M2PP-121-D-PLNM-0001

Appendix 3: BRIDGE SUMMARY- POPLAR AVE BRIDGE  
Site Specific Management Plan 001 - [sector 320]  
MacKays to Peka Peka Expressway

18TH SEPTEMBER 2014 - REV B

AEE PLAN- POPLAR AVENUE CROSSING - 1:500@A3

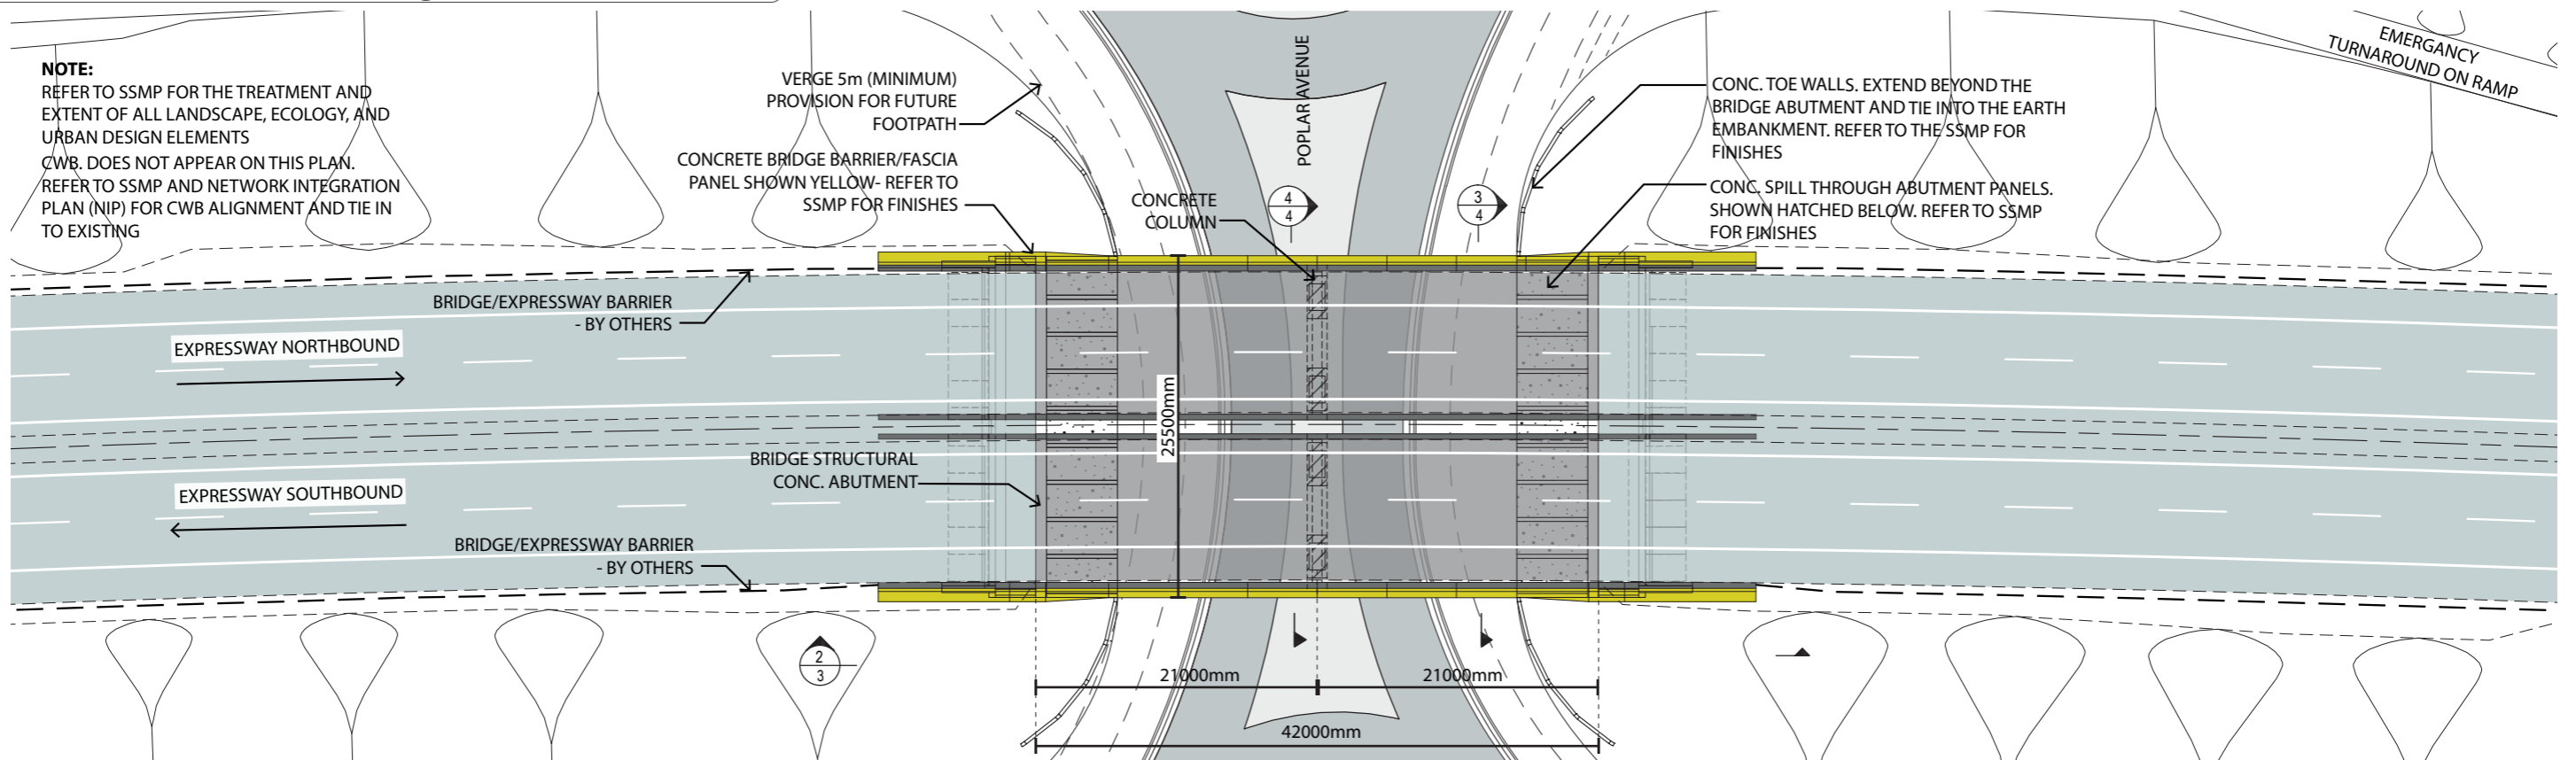
1. Reduced bridge Length. Reduced number of spans from 3 to 2
2. Column locations and number adjusted
3. Column profile developed
4. Local road design developed
5. Removed footpath from under Poplar Ave bridge

6. Change to split deck

1. More efficient bridge design. Columns no longer sit between the verge and spill through abutments.
2. Reduced number of spans, reduce columns - 4 columns vs 8
3. Increased structural core based on geotech investigations carried out post AEE, while still providing the sculptural outer.
4. Local road design refined since AEE. Roundabouts are closer,

5. increased central median  
CWB Connects to old SH1 via Leinster Ave pedestrian bridge. Provision for future pedestrian/cycle link as part of KCDC SH1 revocation work. Refer to SSMP for more detail.
6. Allows light penetration, bridge performs better seismically

2. PROPOSED ELEVATION - POPLAR AVENUE CROSSING EAST ELEVATION - 1:250@A3

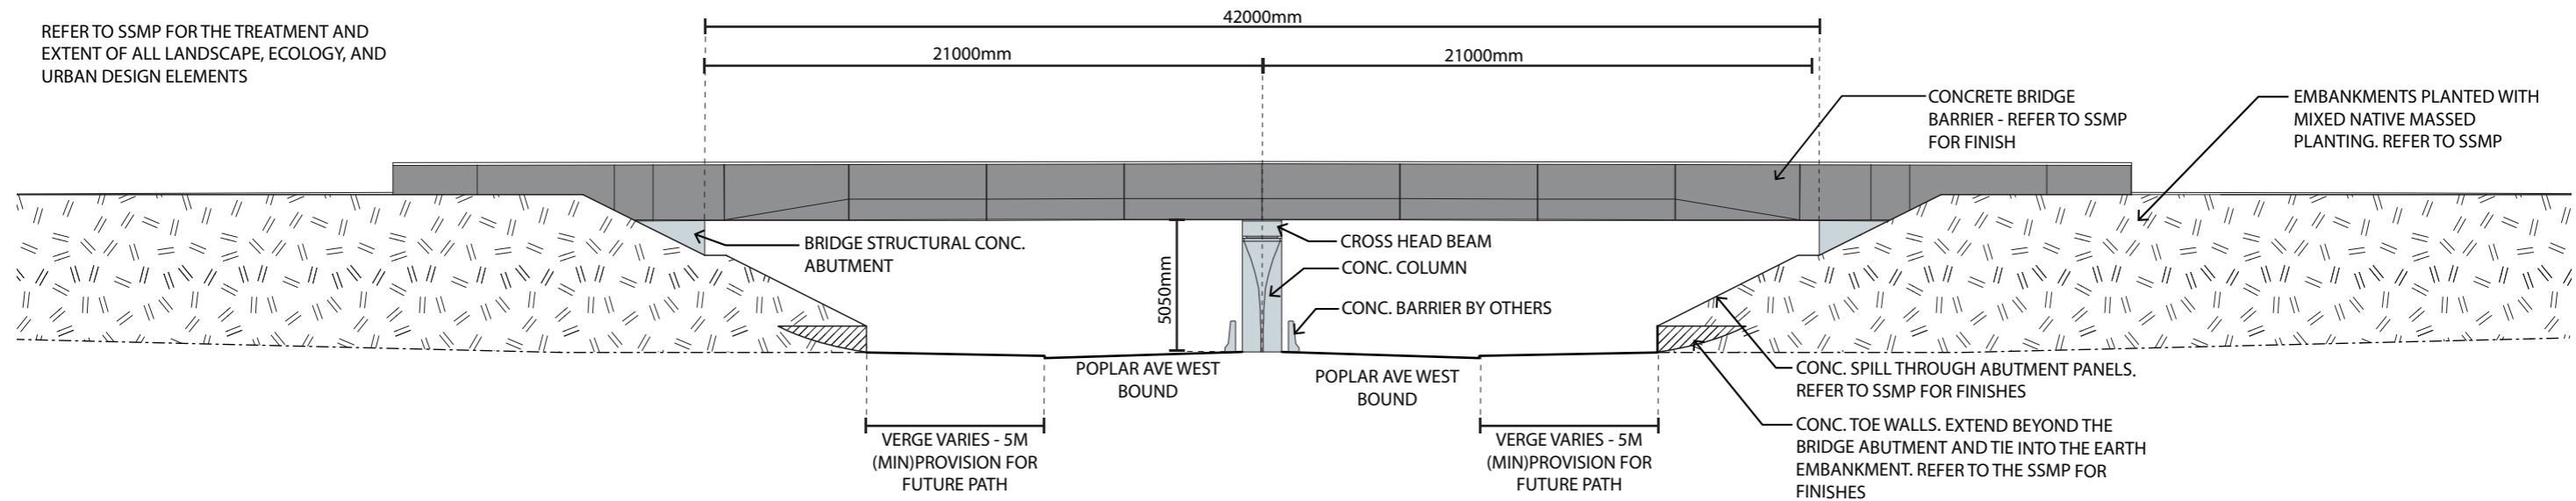
| <ol style="list-style-type: none"> <li>1. Reduced overall length of bridge, Reduced number of spans from 3 to 2</li> <li>2. Column locations adjusted</li> <li>3. Column profile developed</li> <li>4. Local road design developed</li> </ol> | <ol style="list-style-type: none"> <li>5. Removal of footpath under Poplar Ave bridge</li> </ol> |

| <ol style="list-style-type: none"> <li>1. More efficient bridge design. Columns no longer sit between the verge and spill through abutments.</li> <li>2. Reduced number of spans, reduce columns - 4 columns vs 8. Columns moved away from pedestrians.</li> <li>3. Increased structural core based on geotech investigations carried out post AEE, while still providing the sculptural outer.</li> </ol> | <ol style="list-style-type: none"> <li>4. Local road design refined since AEE. Roundabouts are closer increased central median to allow for centrally placed columns</li> <li>5. CWB Connects to old SH1 via Leinster Ave pedestrian bridge. Provision for future pedestrian/cycle link as part of KCDC SH1 revocation work. Refer to SSMP for more detail.</li> </ol> |

3. PROPOSED SECTIONAL ELEVATION - POPLAR AVENUE CROSSING (NORTH ABUTMENT) - 1:200@A3

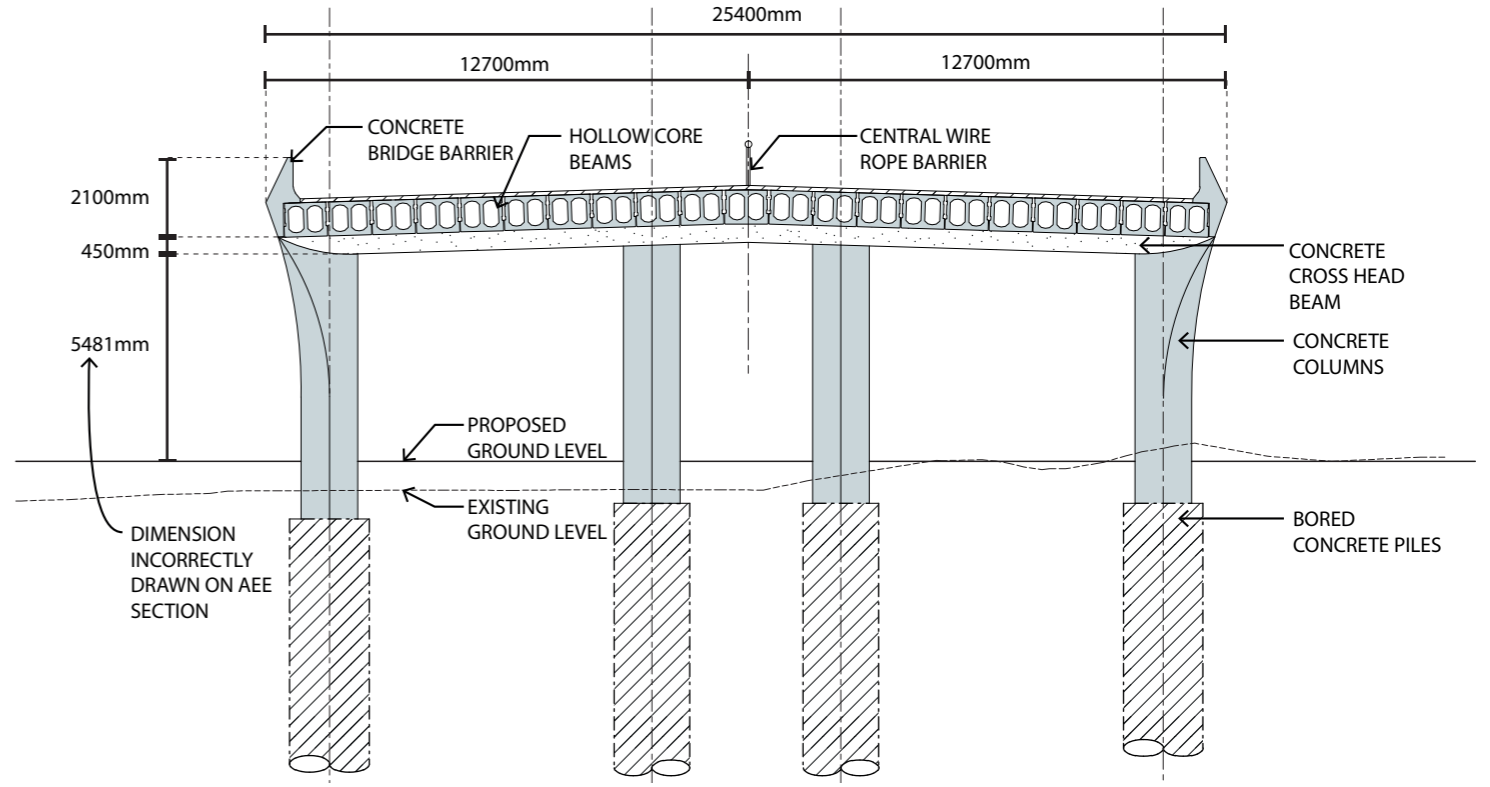
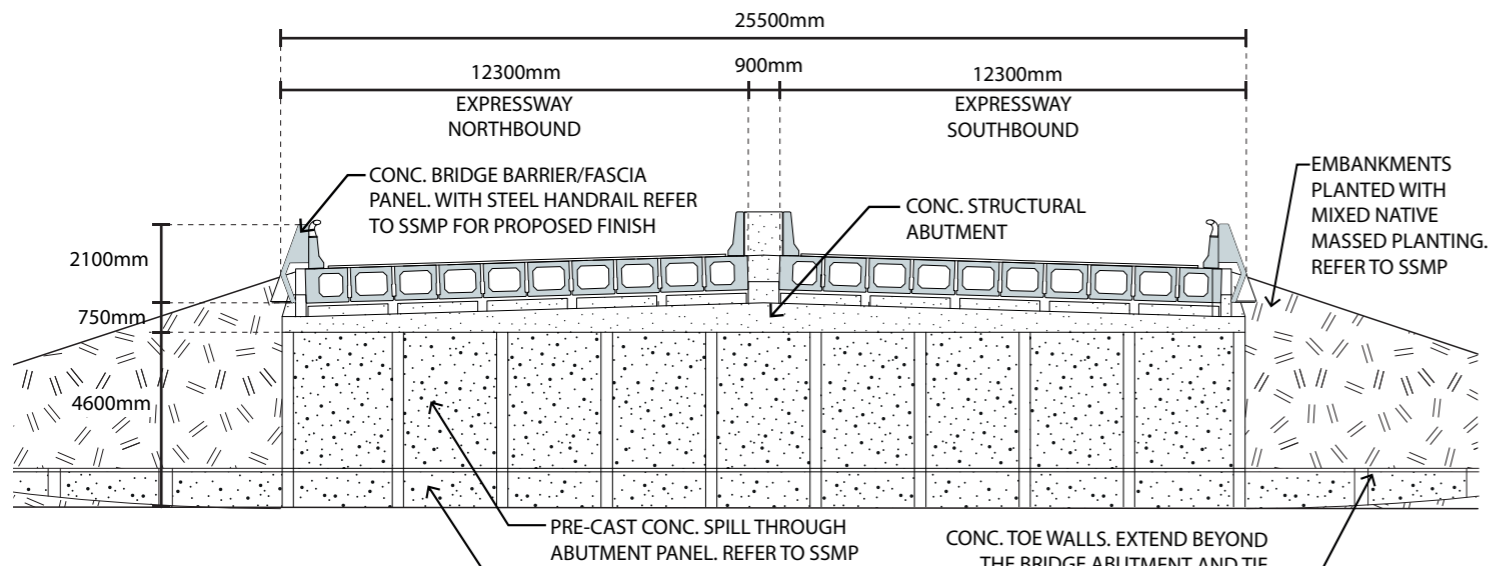
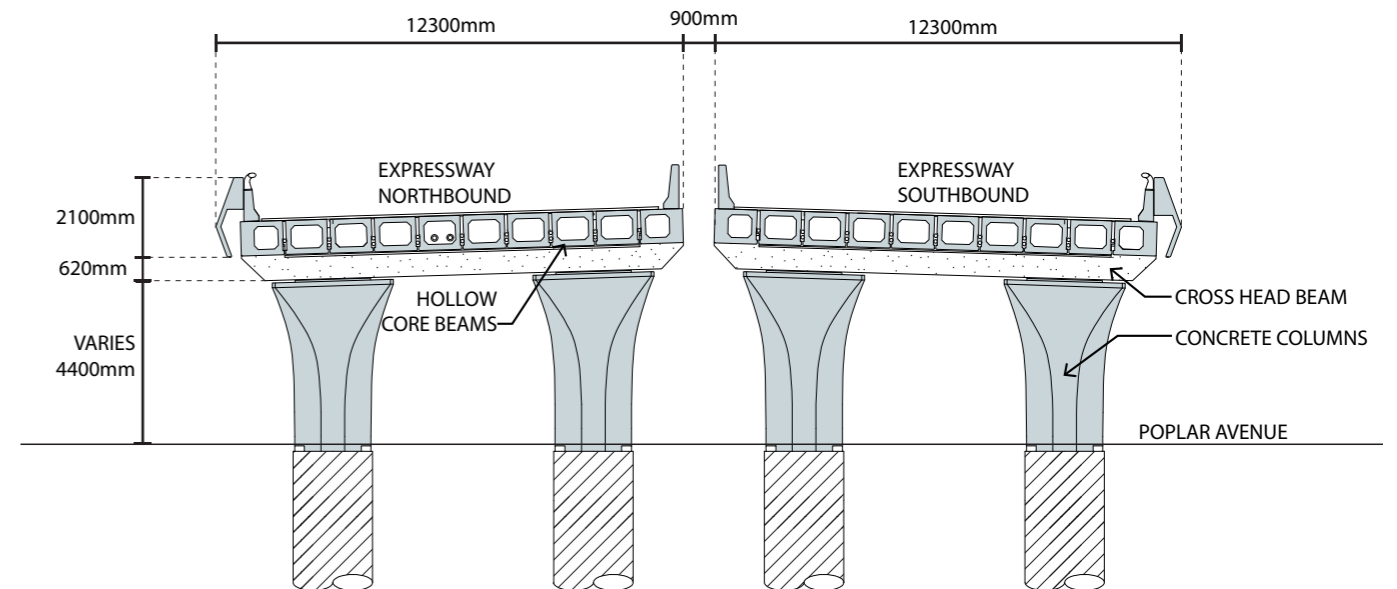
1. More detail provided for abutment treatment
2. Cross head depth has increased
3. Column profile developed
4. Simply supported structure
5. Change to split deck
6. Handrail shown on top of barrier

1. Lack of resolution in AEE. Abutment design developed
2. Simply supported structure requires platform to seat beams
3. Increased structural core based on geotech investigations carried out post AEE, while still providing the sculptural outer.
4. Constructibility issues because of seismic requirements. Integral connections difficult to build without increasing

5. structural element sizes further.
6. Allows light penetration, bridge performs better seismically
7. Safety requirement for cyclists using the expressway
